IEEE 802.3cg

PCLA Timings

May 8th, 2019

- **Comments:**
 - i-191 (Tim Baggett)
 - i-320 (Tim Baggett)

SETUP REQUIREMENT

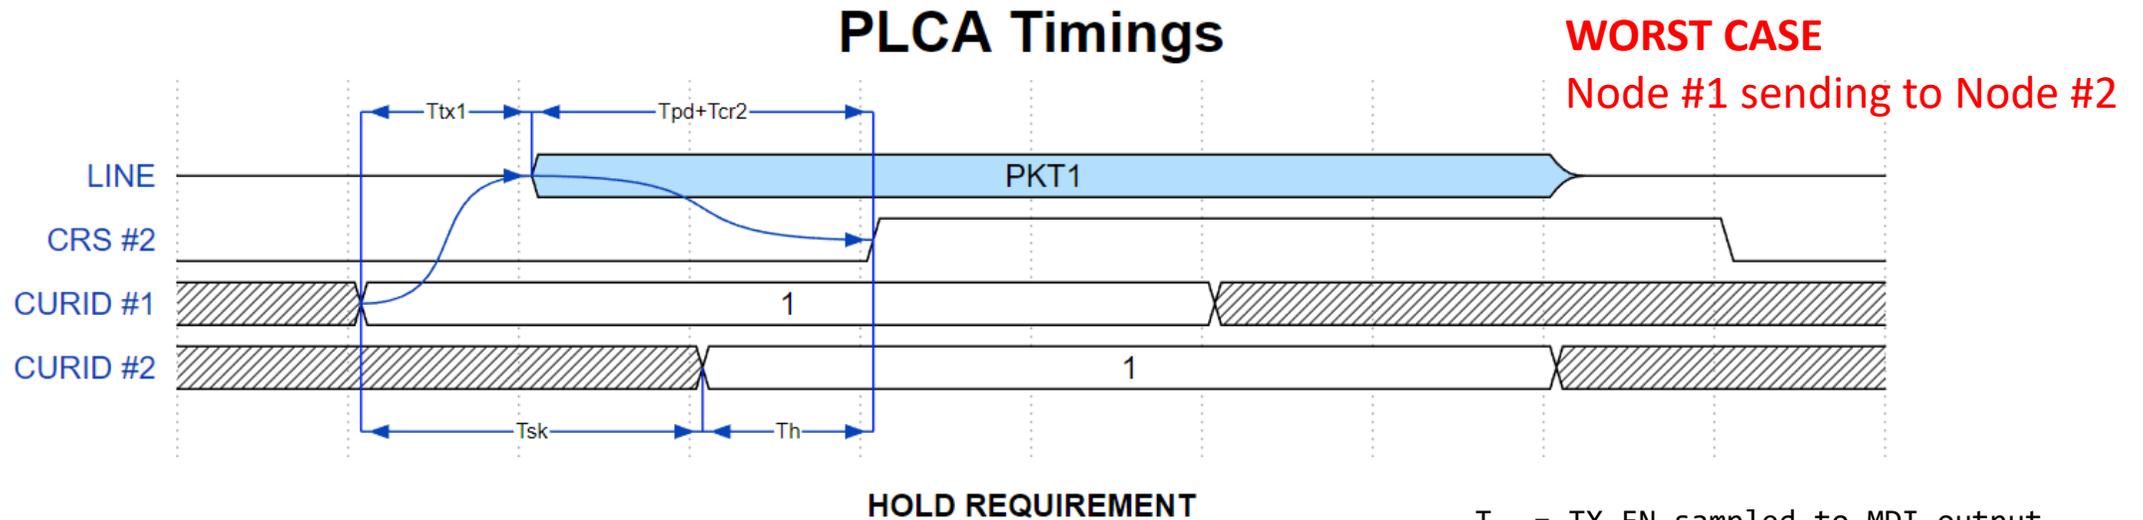
$$T_{su} = TO_{timer} - (T_{sk} + T_{tx2} + T_{pd12} + T_{cr1})$$

$T_{su} > 0$ to meet the TO

Worst case T_{su} is for max T_{sk} , max T_{tx} , max T_{pd} and max T_{cr} which gives:

$$\text{Eq. 1: } \max T_{tx} + \max T_{cr} + \max T_{cf} - \min T_{cf} < TO_{timer} - 2 \max T_{pd}$$
